PLANNING COMMISSION

May 8, 2024 – 7:00 PM

Re: Site, Building and Sign Plan Review Requests – Chase Bank

Mr. Terron Wright, representing the applicant, the Architects Partnership Ltd., has applied to the City for Site Plan approval for a new retail banking center. Specifically, they are proposing a new 3,432 square-foot Chase Bank building with a drive-up ATM and associated parking on the property located at 1232 Broadway Avenue West. The property in question is located on the south side of Broadway Avenue, west of 12th Street Southwest and is the site of the former Kentucky Fried Chicken Restaurant.

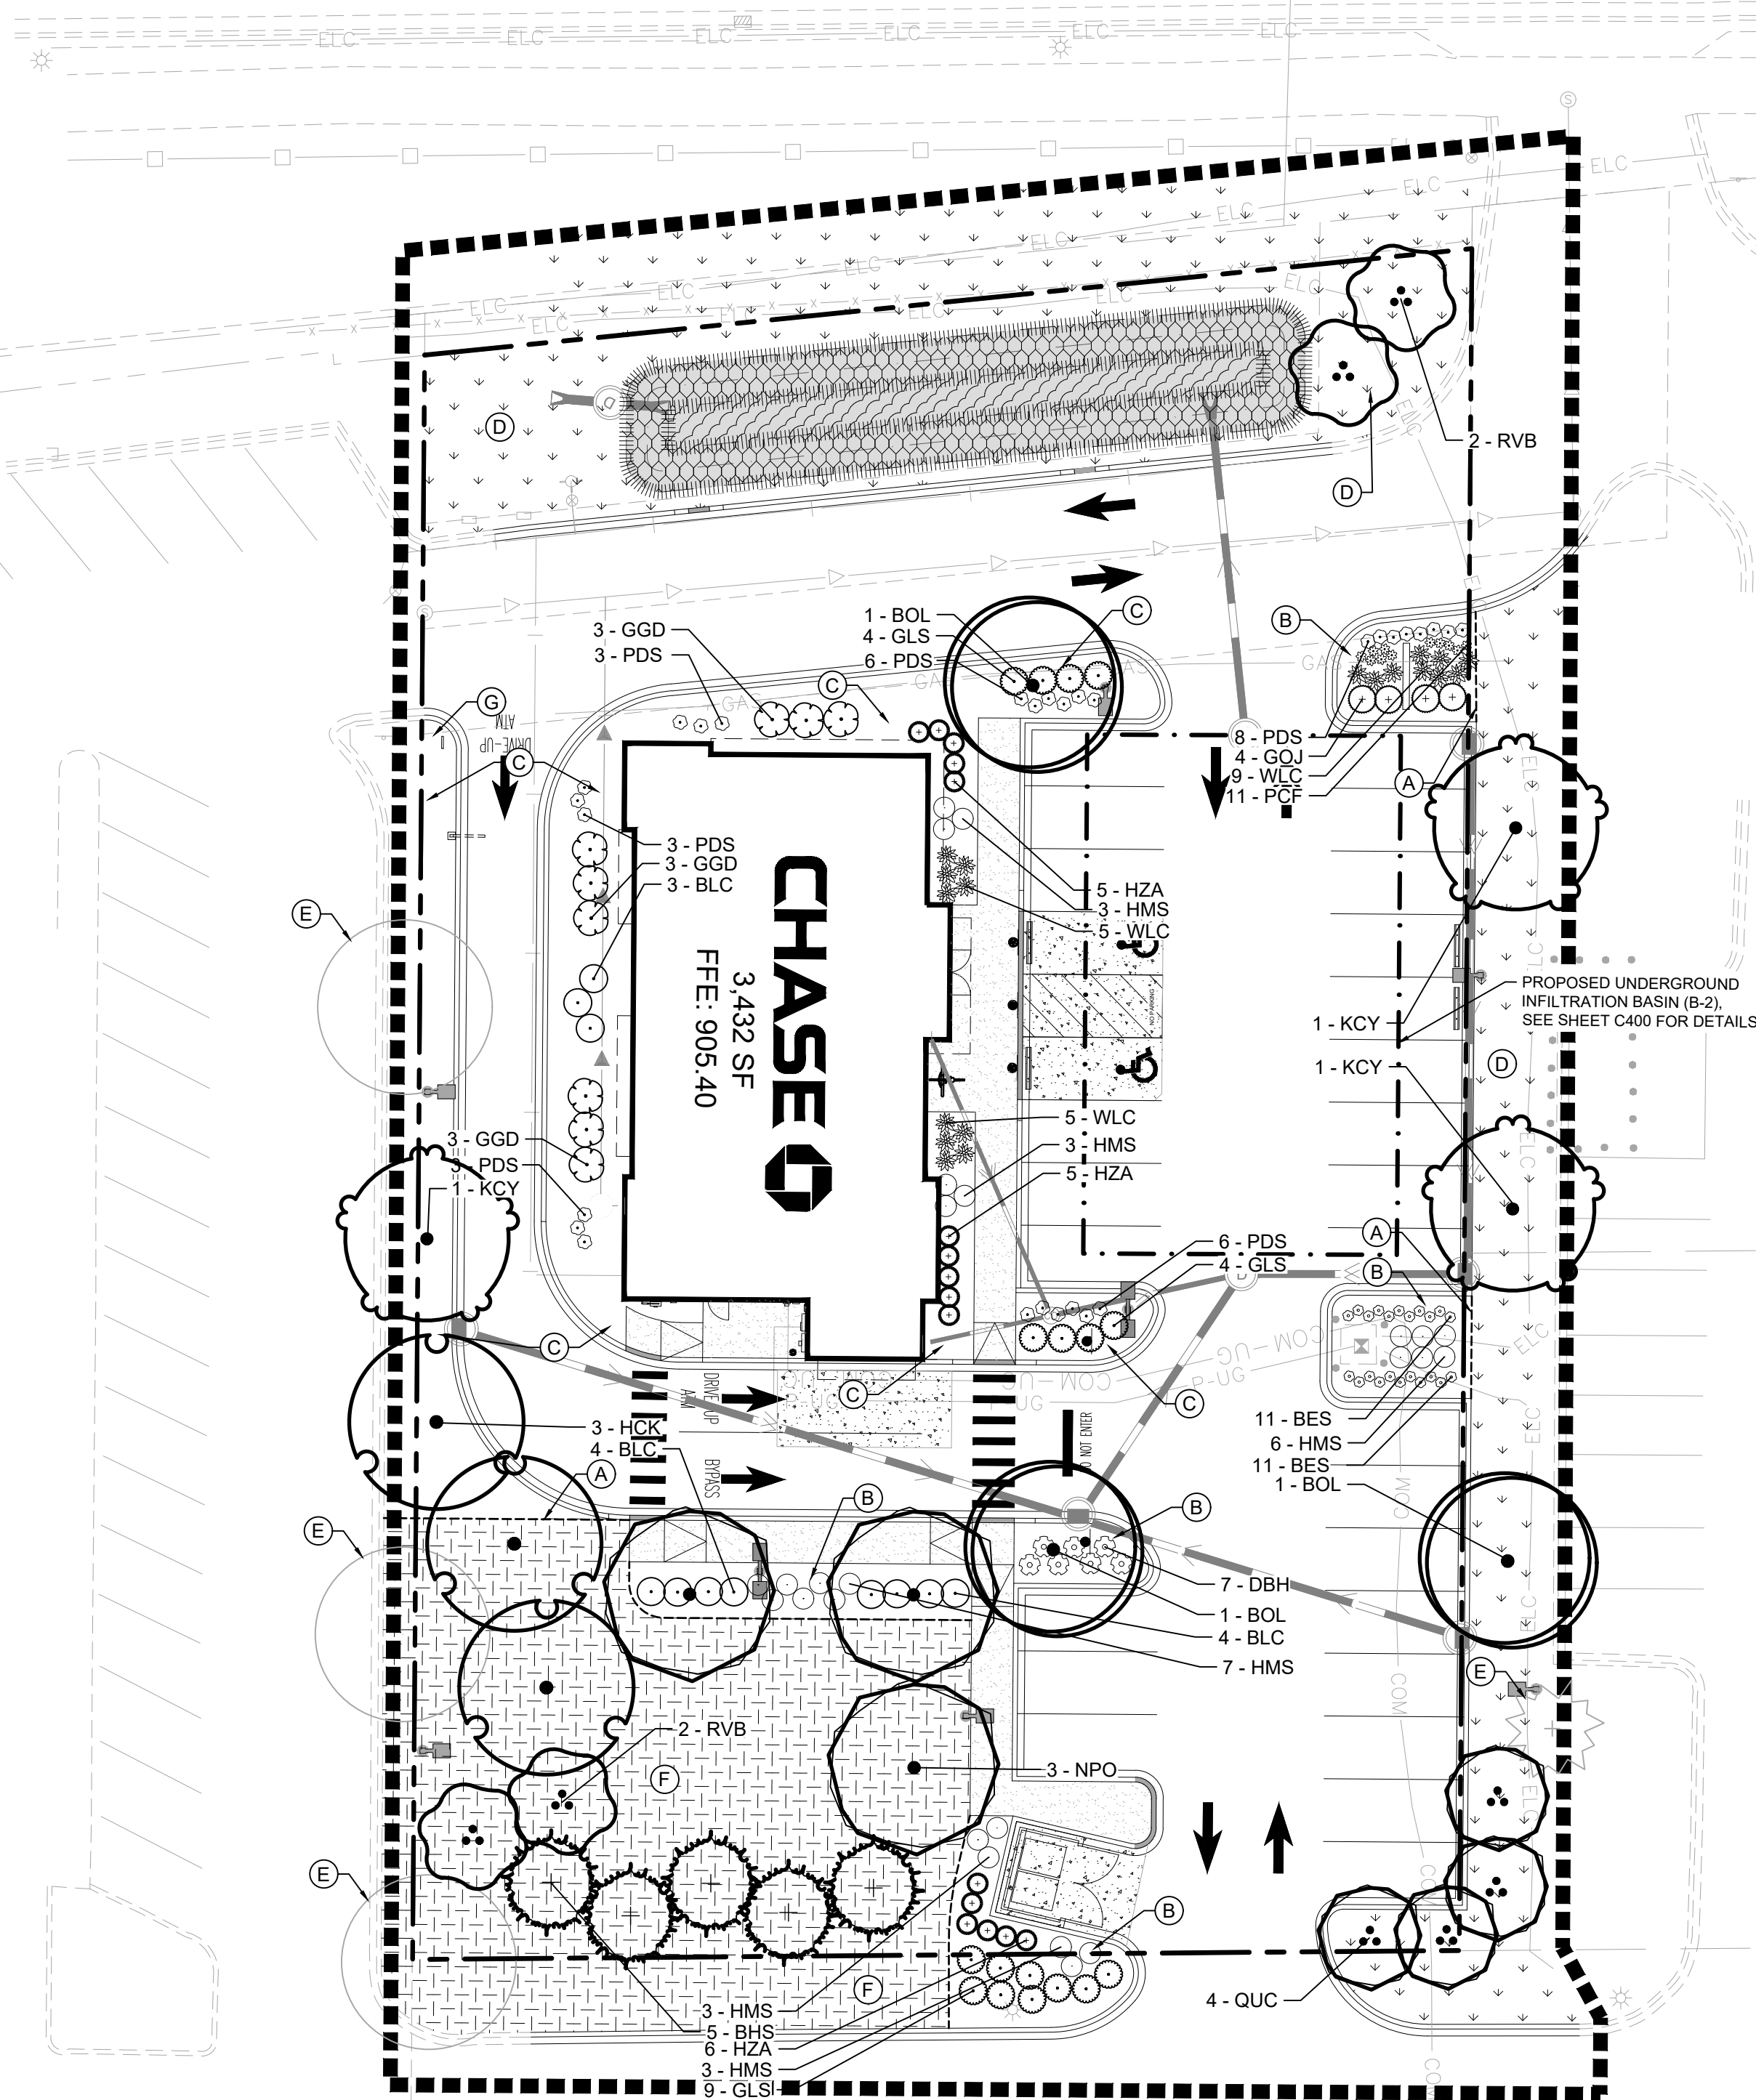
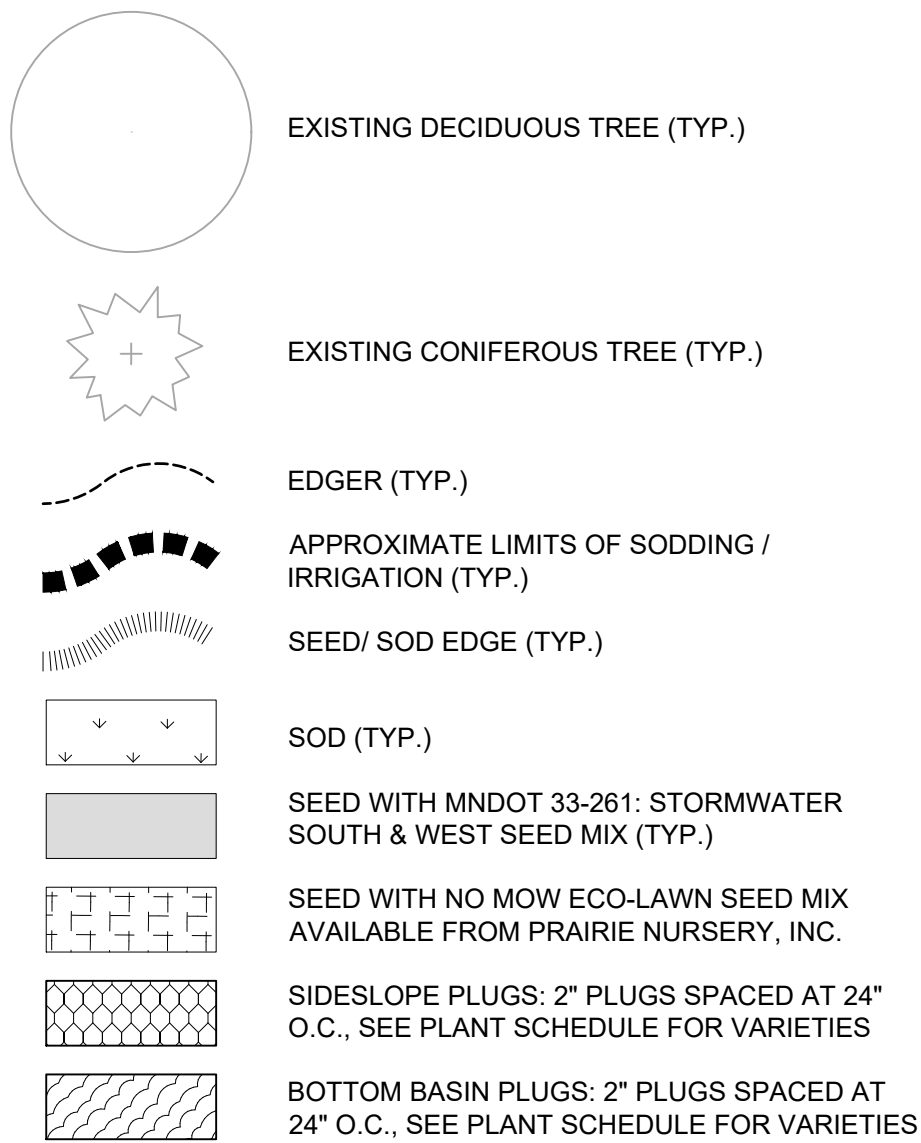
The proposed landscaping plan details five variety of trees for the 17 trees considered to be overstory trees. As noted in the table above, the proposed tree planting plan has six fewer over story trees than required by the City Code. This is because the proposed plan included 8 ornamental trees with 1.5-inch diameter trunks the applicant included in the count of proposed overstory trees. The City requires overstory trees to have trunks that are at least 2.5-inches in diameter. As such, the applicant will need to revise the size and types of those 8 trees to meet the City requirements as overstory trees.

In addition, the proposed landscaping plan shows the planting of 3 overstory trees and 2 quaking aspen clumps on the property to the east of the proposed parking lot in the area where the existing parking lot will be removed. The applicant and property owner will need to secure written permission from the adjoining property owner to the east the subject property to work on and to install landscaping and trees on the adjoining property.

As the above table also shows, the applicant is proposing to plant 23 fewer understory trees and shrubs than required by the Code. It appears to staff the applicant is proposing to plant as many shrubs as possible on the site due to the existing site constraints of the property. The proposal will need to continue meeting species diversity requirement as none of the proposed species shall constitute over 50% of plantings. City staff expects the proposed landscaping to complement this site and development on adjacent parcels.

- f. Revised landscaping and tree planting plans showing there will be at least 26 overstory trees with a trunk diameter of 2.5 inches installed with the project after the contractor has completed all site and landscape work.

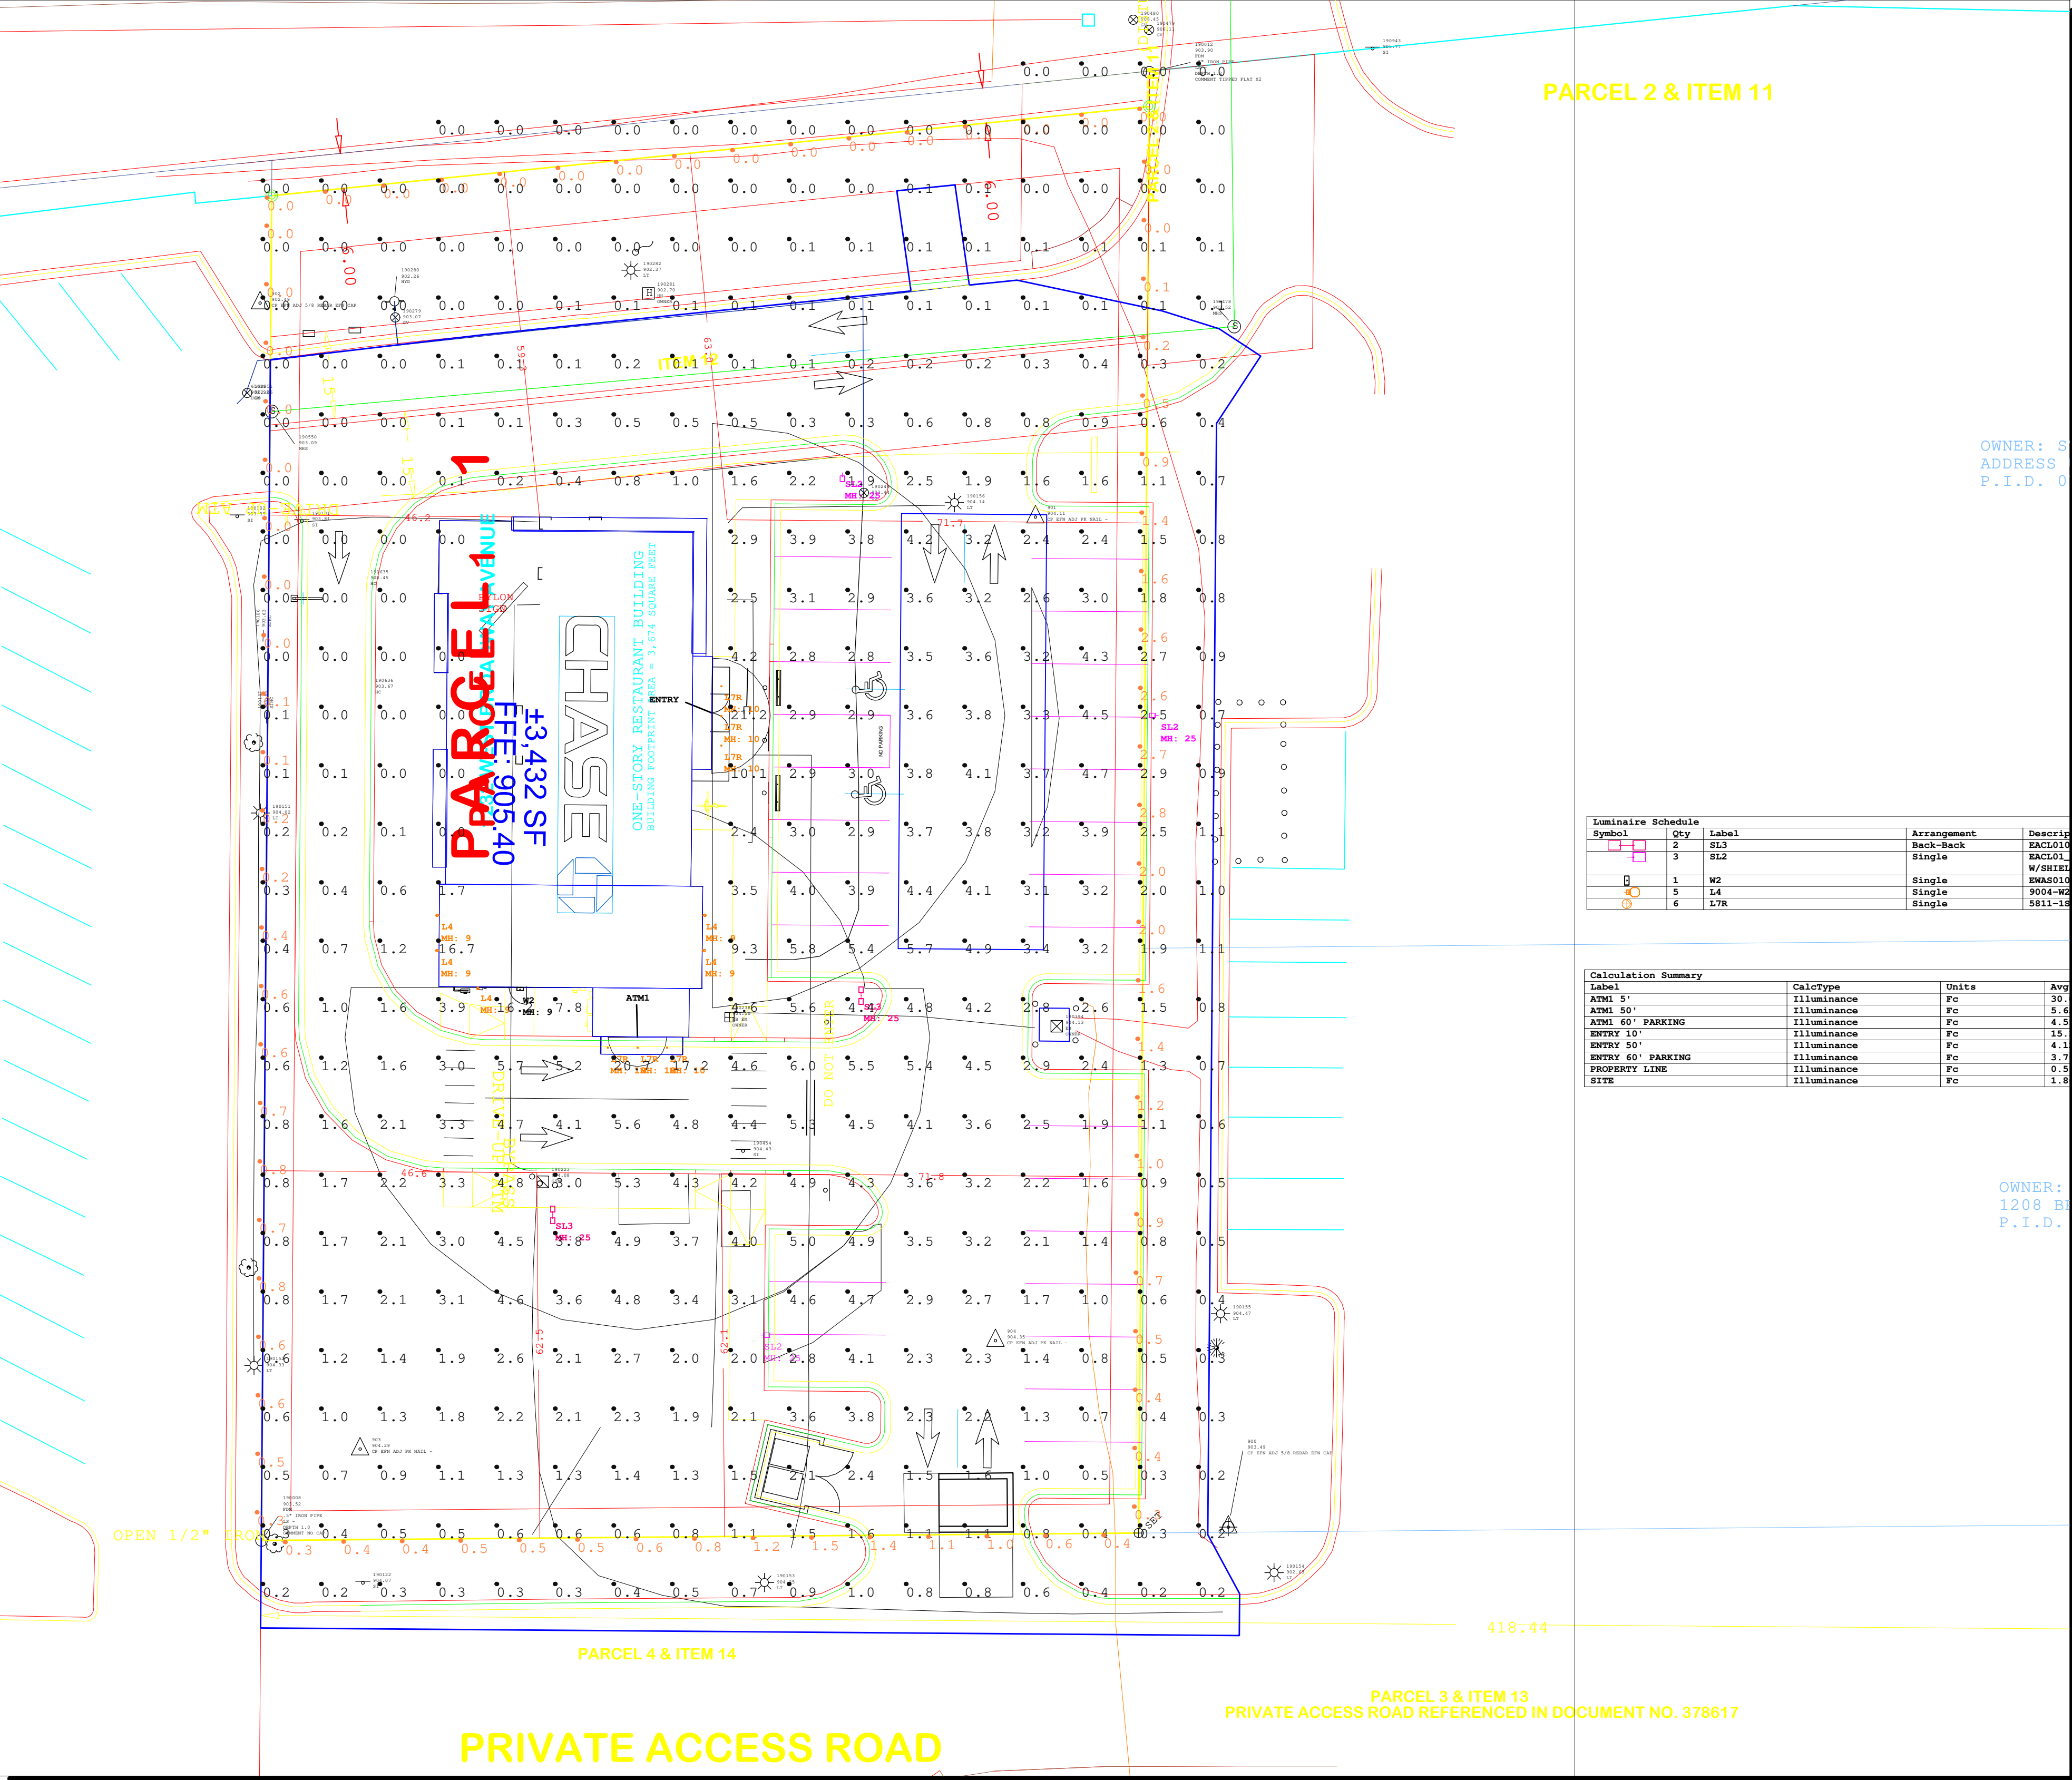
Lighting Plan – Lighting standards are established in City Code Section 153.130. The Applicant’s preliminary lighting plan is not consistent with City standards for exterior lighting because the plans show lighting at the 3 of the 4 property lines exceeding the maximum standard of 0.4-foot candles. The height of freestanding lighting poles is shown to be 25 feet which meets the City Code requirement. Staff is recommending the applicant submit a revised exterior lighting plan that meets City standards before the City issues any permits for site work for this project.

EAST ELEVATION

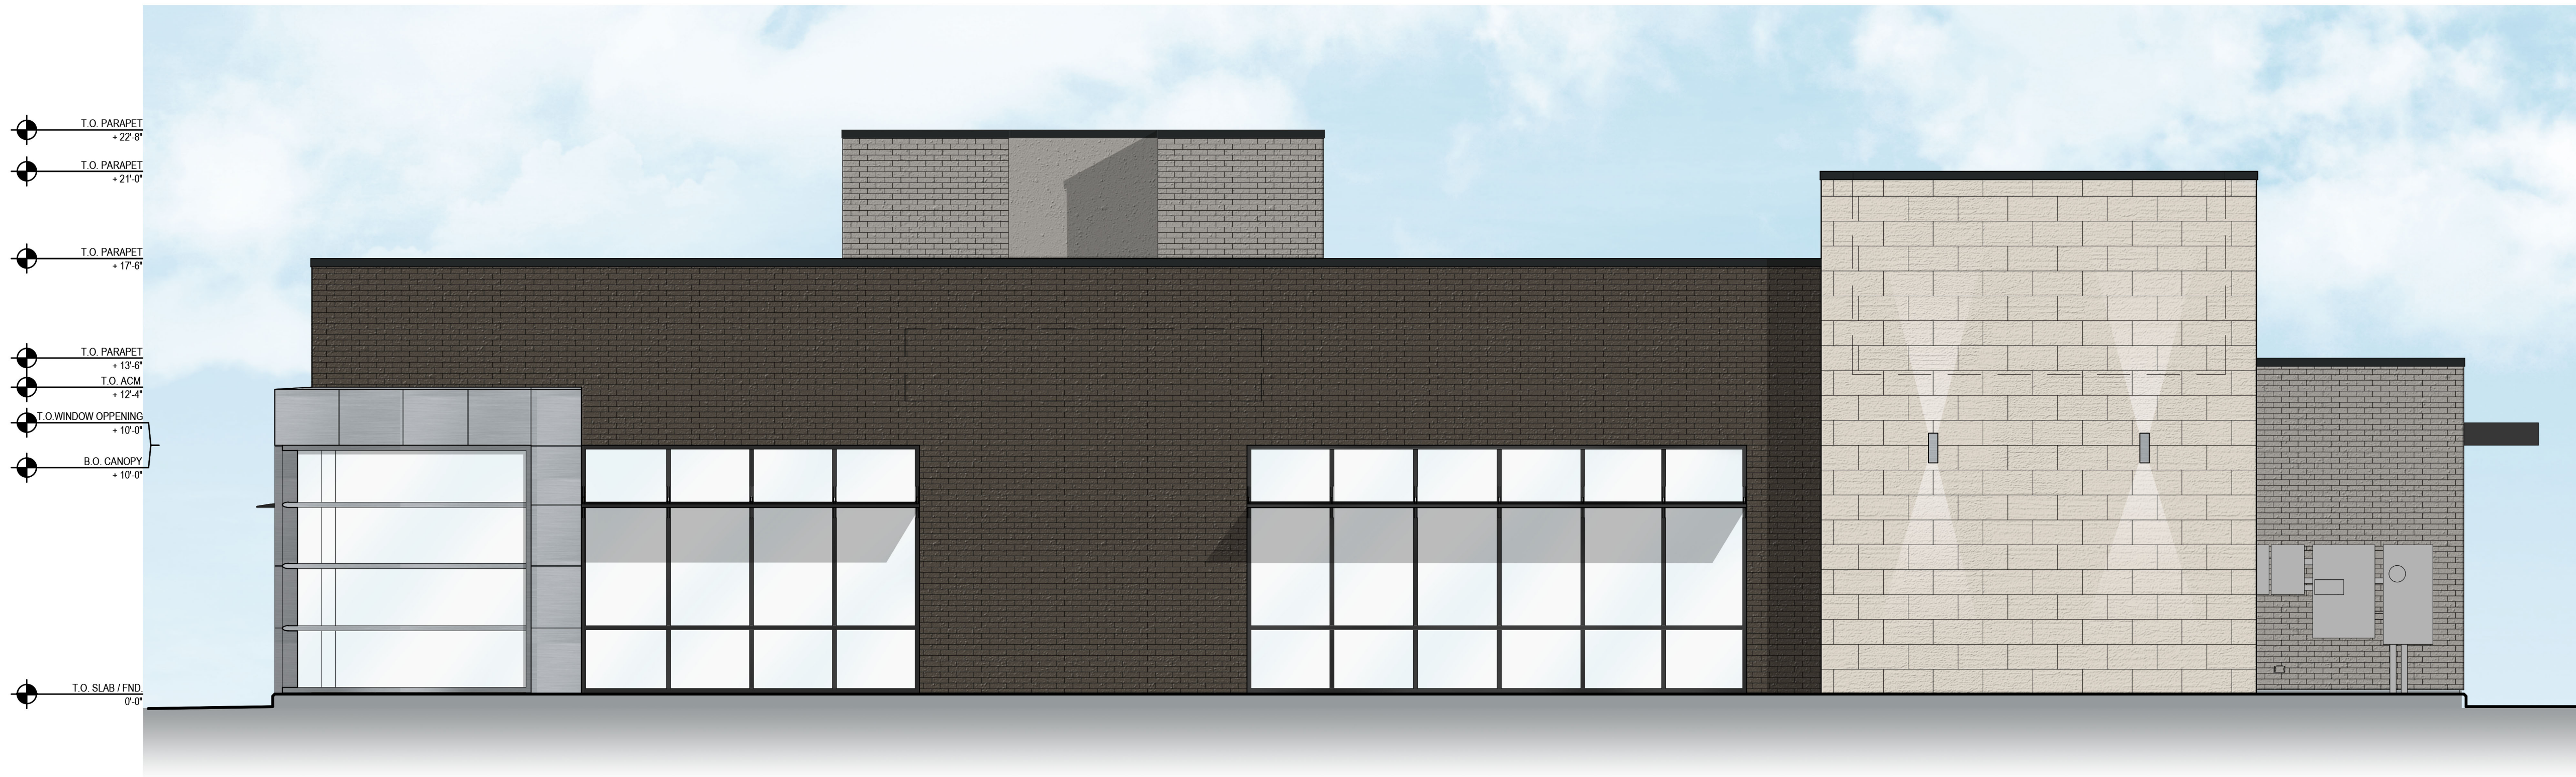
not clear to staff if there will be any roof-top equipment. The proposed building elevations show parapets extending above the roof deck possibly to help screen roof top equipment. The City should require the applicant to submit project plans that clearly show the roof top equipment (if any) and proposed screening to ensure the roof top units are not visible from Broadway Avenue.
